UNITED STATES ENVIRONMENTAL PROTECTION AGENCY
REGION IX
75 Hawthorne Street
San Francisco, CA 94105-3901

Subject: Transmittal of "Port of Stockton Municipal Separate Storm Sewer Audit Report"

**Port of Stockton
Municipal Separate Storm Sewer System (MS4)
Audit Report**

Photograph 1: An actively disturbed slope located adjacent to a drainage ditch along Navy Drive and southeast of the construction site entrance.

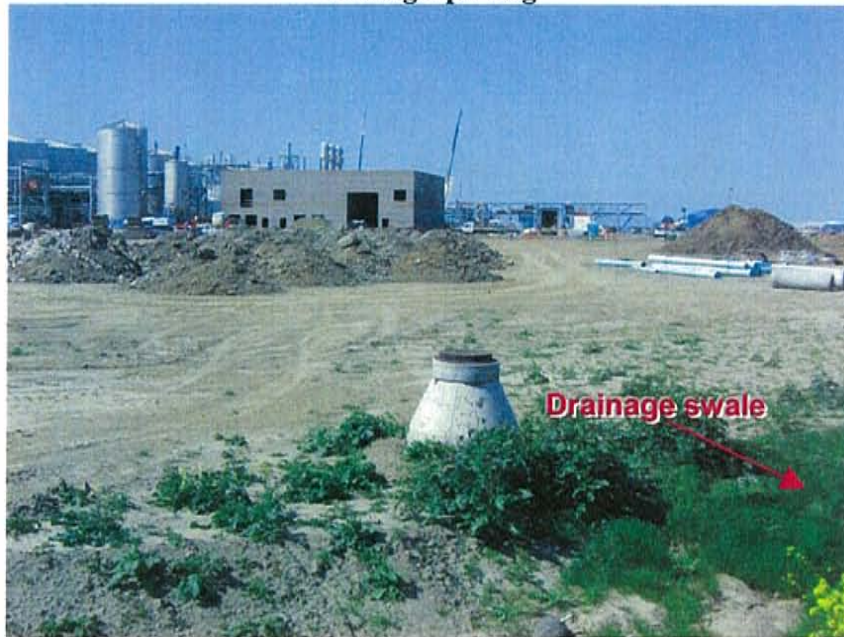
Section C.7.a.ii of the Order requires that Port inspections of construction sites ensure that sediments generated at a project site are retained on-site and that erosion from slopes and channels is controlled by implementing an effective combination of erosion and sediment control BMPs. It was observed during the audit that BMPs were not implemented to prevent the discharge of sediment from an actively disturbed slope adjacent to a drainage channel along Navy Drive and southeast of the construction site entrance (Photograph 1). BMPs were not implemented between the slope and the adjacent drainage channel or in the disturbed drainage channel itself, and the surfaces of the slope and channel were not stabilized (Photograph 2). As a result, there was a potential for the discharge of sediment from the disturbed slope and drainage channel leading to the South Ditch and East Complex Retention Basin. In addition, BMPs had not been implemented between a large expanse of disturbed soils, a number of uncontrolled soil stockpiles, and the adjacent drainage swale (Photographs 3 and 4). Evidence of erosion, including rill formation on the slope of the drainage swale (Photograph 4), was observed. The Port Construction Site Inspector explained that the drainage swale that encompasses the site discharges through a storm drain outfall into the drainage channel along Navy Drive (Photograph 5), leading to the South Ditch, East Complex Retention Basin, and ultimately the San Joaquin River. BMPs must be installed, inspected, and maintained to prevent the discharge of sediment from the aforementioned disturbed areas of the site to the drainage channel along Navy Drive. Moreover, the Port must ensure that

Photograph 2: BMPs were not implemented between the slope and the adjacent drainage channel or in the disturbed drainage channel itself, and the surface of the slope was not stabilized.

sediments generated at the Pacific Ethanol project site are retained on-site and that erosion from slopes and channels is controlled by implementing an effective combination of erosion and sediment control BMPs.

Photograph 11: View of Lowe's Distribution Center equipment maintenance shop.

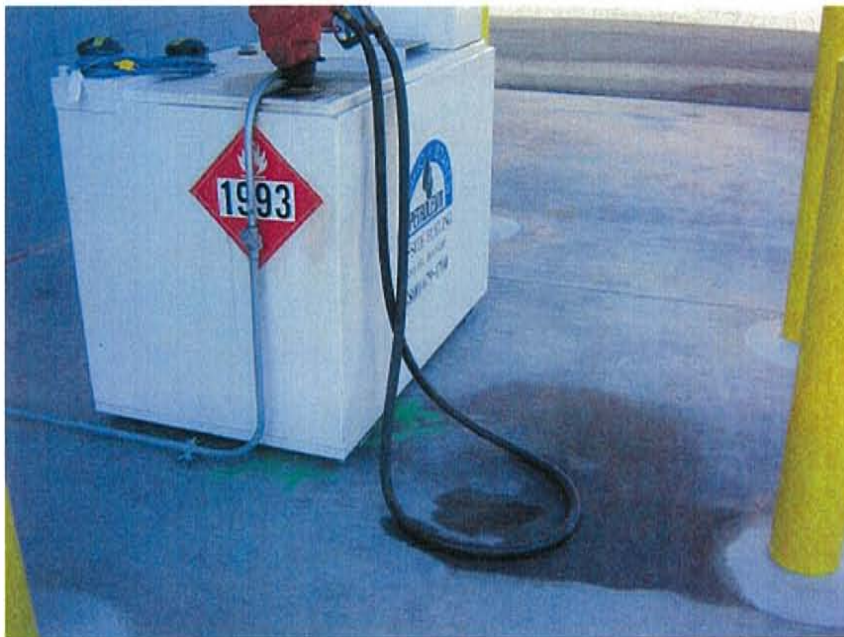
The Lowe’s Distribution Center is a completed commercial project consisting of a warehousing and distribution facility for home improvement goods and building and construction materials. Section C.14.a.v of the Order defines the parking lot category as “parking lots exposed to rainfall that are 5,000 square feet or more, or with 25 or more parking spaces.” The site includes a newly constructed equipment maintenance (Photograph 11) and fueling (Photograph 12) shop and approximately 20 acres of

impervious parking improvements (Photographs 13 and 14). As a result, this project likely qualifies as a Priority Development Project under both the commercial and parking lot categories. Based on Port records provided during the audit, the Lowe's HIW, Inc., lease approval date (September 5, 2006) and construction start date occurred after the February 17, 2006, DSP compliance date (Exhibit 4) and therefore should have been reviewed and conditioned for compliance with the Development Standards.

Photograph 12: View of Lowe's Distribution Center fuel storage tank located adjacent to the maintenance shop.

Because of the likelihood that additional projects qualify as Priority Development Projects, the Port must review all completed projects initiated since the Order effective date (October 15, 2004), as well as all current and proposed construction and development projects, for DSP applicability. The Port must develop a list of these projects, including all data necessary to determine whether the projects qualify as Priority Development Projects. The required data include but are not limited to project description at build-out, land use, impervious land area for development (square feet), area of impervious surface created or replaced (square feet), Standard Industrial Classification (SIC) code, number of parking spaces, and all other data relating to the Priority Development Project Categories specified in Section C.14 of the Order. As a component of the list, the Port must make an initial Priority Development Project Category determination regarding the need for DSP conditioning and supporting rationale.
